STAFF RECOMMENDATION

117 Windsor Drive

February 17, 2021

Application: New Construction—Addition

Figure 1: 117 Windsor Drive

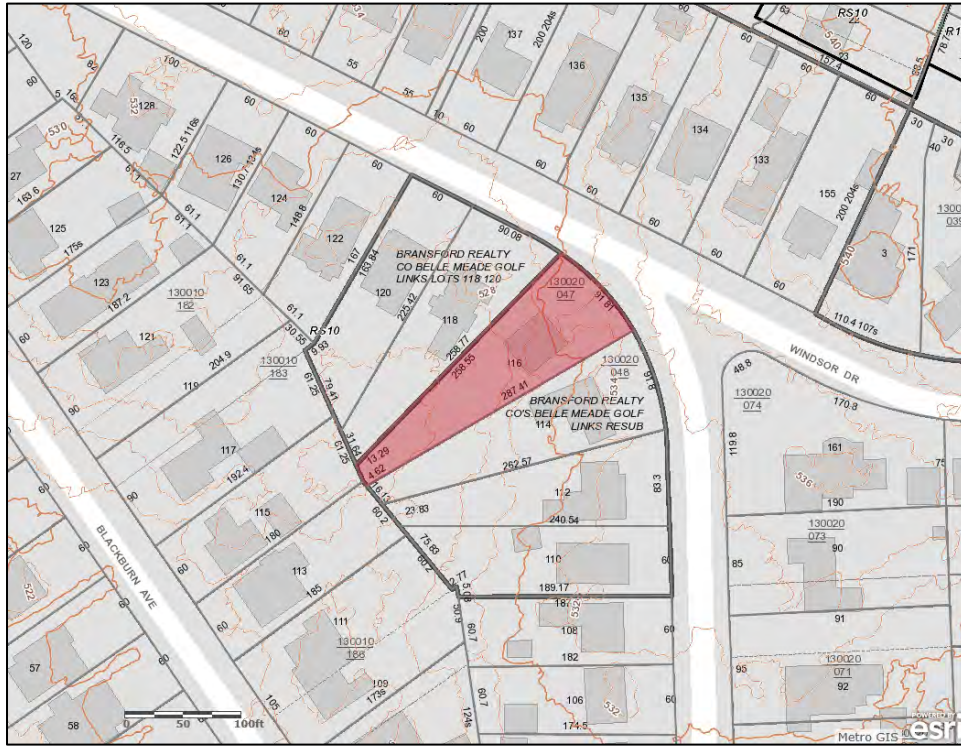
Background: The structure at 117 Windsor Drive is a one and one-half-story house, constructed circa 1925. The house is brick and stone on the first story, with stucco in the upperstory gable fields.

The house has been enlarged with a rear dormer addition and a small first story rear addition, but the front and sides of the historic house are intact.

The house has elements of the Craftsman and Tudor Revival styles and is contributing to the historic character of the district because of its age and architectural character.

Figure 2: First floor plan of proposed rear addition. The front of the existing house is to the right.

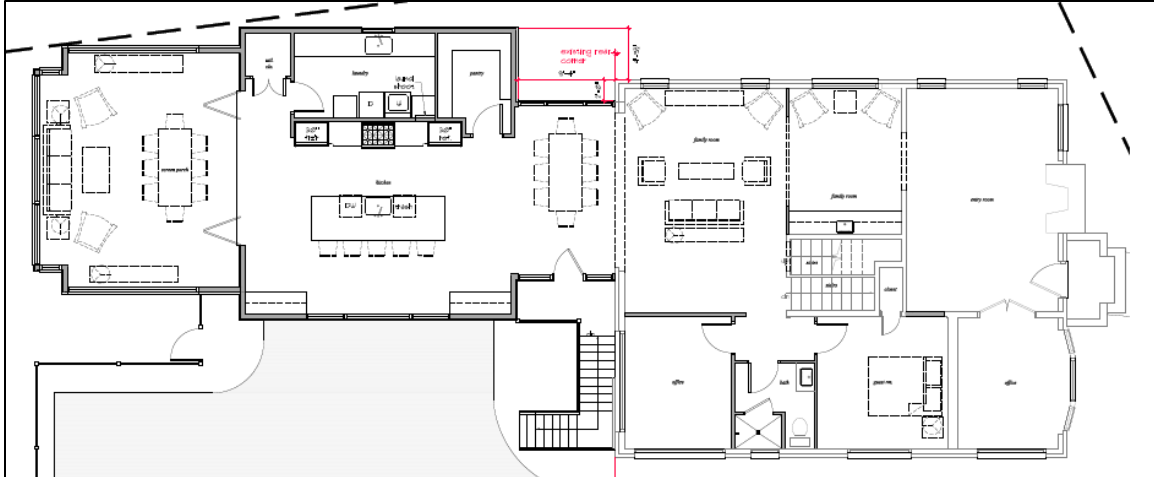
Height & Scale: On the right side, the addition will step in two feet (2') and then after going back nine feet, four inches (9'-4") it will step out to the right, going four feet, ten inches (4'-10") wider than the historic house. The primary mass of the addition then extends twenty-five feet (25') back, before stepping back in. The left side of the addition is stepped in sixteen feet (16') from the side of the house, and extends back entirely within the silhouette of the historic house. The depth of the addition's primary mass is thirty-four feet (34') to the historic house's forty-two feet (42'), and the footprint is eight-hundred, twenty-five square feet (825 sq. ft.) to the current footprint of one thousand, four hundred, fifty square feet (1450 sq. ft.), with a one-story screened porch adding another nineteen feet (19') of depth and four hundred square feet (400 sq. ft.) of area.

In general, additions should be kept within the silhouette of an historic house, but Staff finds the additional width for this project to be appropriate because of the size, shape, and slope of the lot.

The roof of the addition will tie into the existing roof at the ridge and will have a matching eave height. The addition will have a one and one-half story form matching that of the historic house, with a basement-level garage, and because the eave and ridge heights match the historic house, Staff finds that it will be subordinate to the historic form.

Staff finds the height and width of the proposed addition to meet Sections II.B.1.a. and b. of the design guidelines.

Figure 3: Left elevation of proposed rear addition. The front of the existing house is to the right.

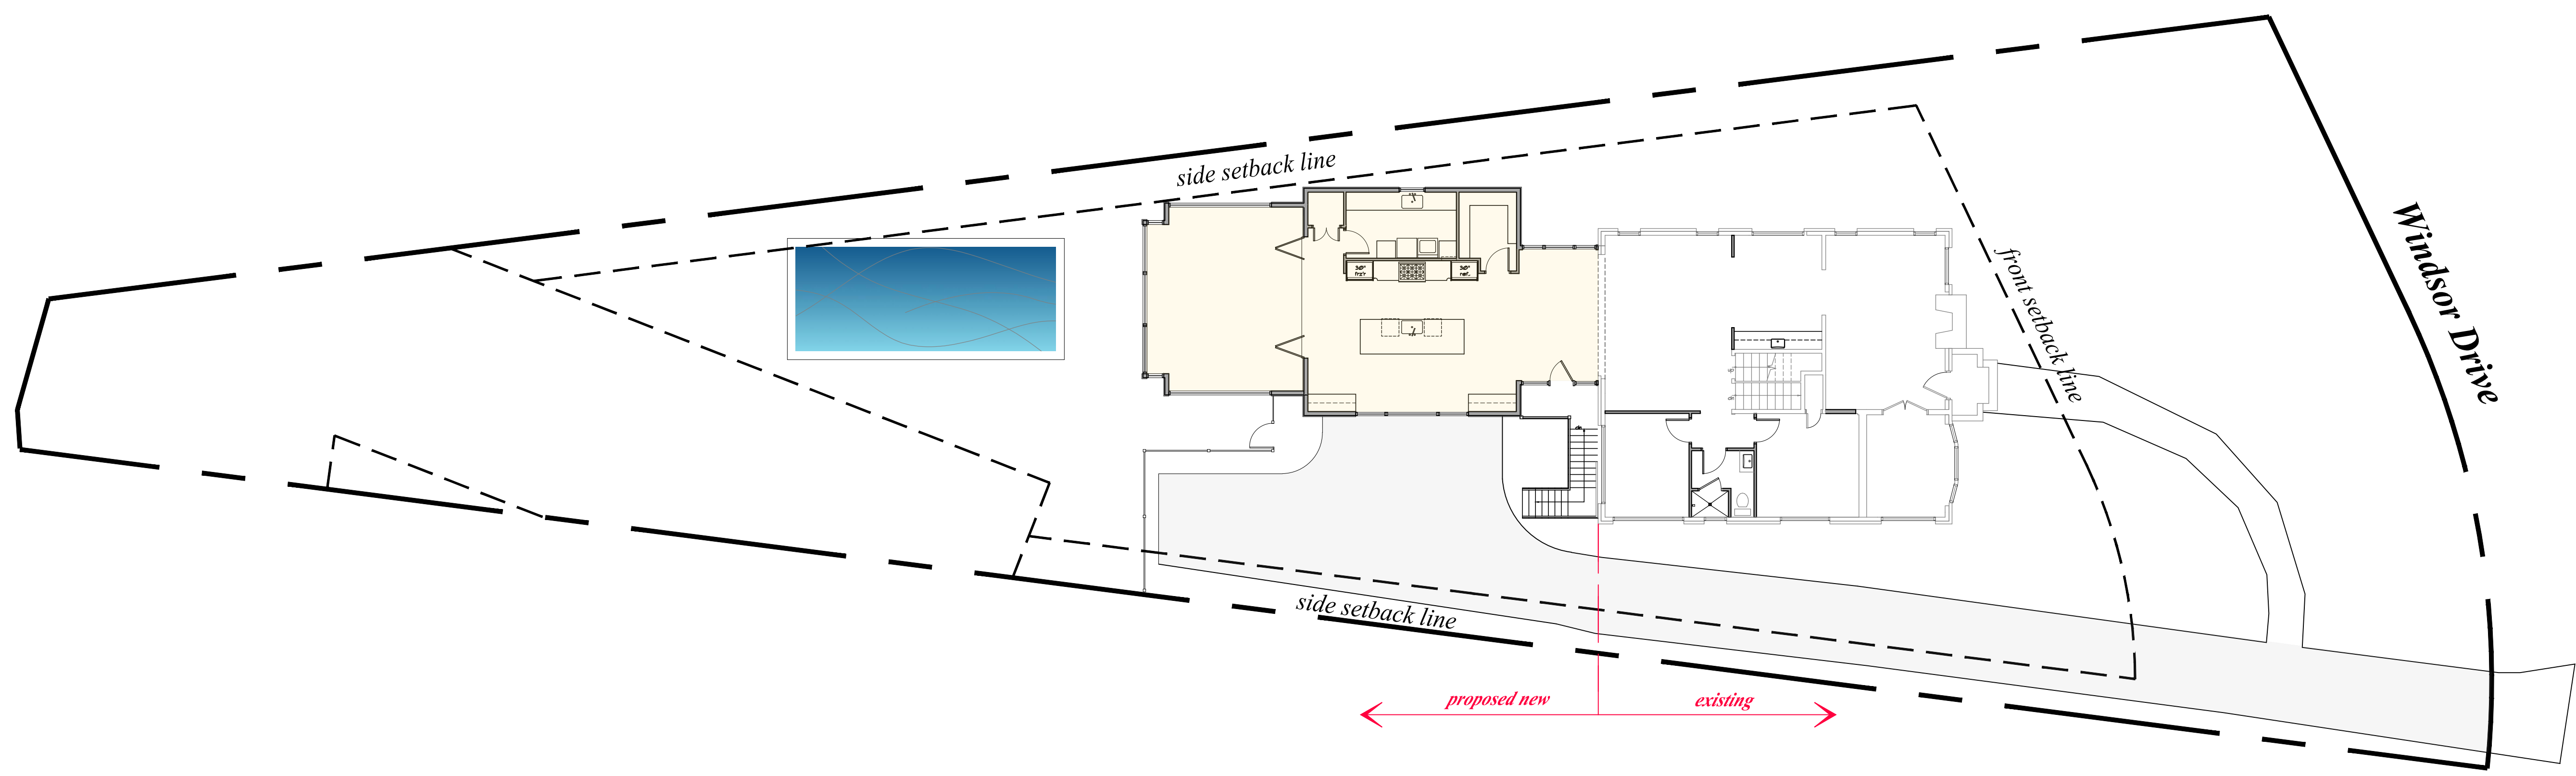
Setback & Rhythm of Spacing: After an inset portion at the rear of the house, the addition will step out four feet, ten inches (4'-10") wider than the house on the right side. The addition will meet the five foot (5') setback requirement from the right property line. The addition is stepped in sixteen feet (16') on the left side and will remain well inside the silhouette of the historic house and will not come within twenty feet (20') of the left side of the property. The rear of the addition will be no less than one hundred, twenty-five feet (125) from the rear of the property.

Staff finds that the setbacks of the proposed addition are appropriate and meet Section II.B.1.c. of the design guidelines.
